Subject: 10CFR21 Reporting of Defects and Non-Compliance -  
Engine Systems, Inc. Report No. 10CFR21-0121, Rev. 0

Refurbished Pressure Regulator Assembly, P/N 1776 506

COMPONENT: Pressure Regulator Assembly - Component Omitted During Refurbishment  
P/N 1776 506

SYSTEM: Emergency Diesel Generator

**Figure 1: Outline Dwg of Pilot Valve Portion of Regulator Assembly**

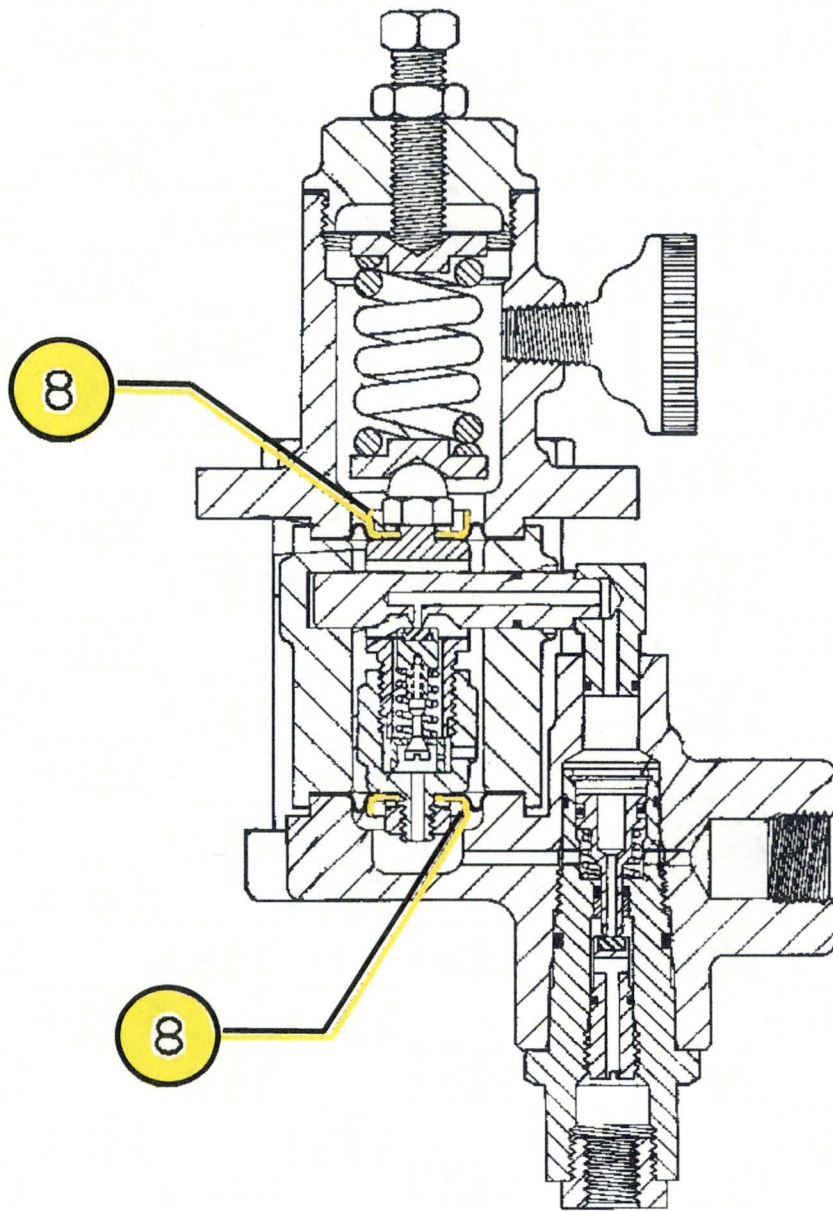
*ESI supplied a refurbished pressure regulator assembly, P/N 1776 506, S/N 20776487, to Brunswick Nuclear Plant in August 2017. ESI later determined that two components of the assembly, an upper and lower diaphragm plate, were omitted during reassembly of the refurbished regulator. Reference item 8 on Figure 1 for location of the diaphragm plates within the pilot valve portion of the regulator assembly. These metal diaphragm plates distribute load and retain the associated rubber diaphragm. Omission of the metal plate may not initially affect operation of the pilot valve and therefore may not be detected during functional testing; however over repeated cycles there is a strong possibility that the rubber diaphragm would tear or rupture without the benefit of load distribution and support provided by the metal diaphragm plate.*

Item 8 is the diaphragm plate

*The assembly has been recalled and will be reworked by ESI using a new, dedicated repair kit and re-assembled and tested per approved procedures. An additional QA inspection will be performed to ensure presence of the diaphragm plates. This activity will be completed within the next 30 days.*
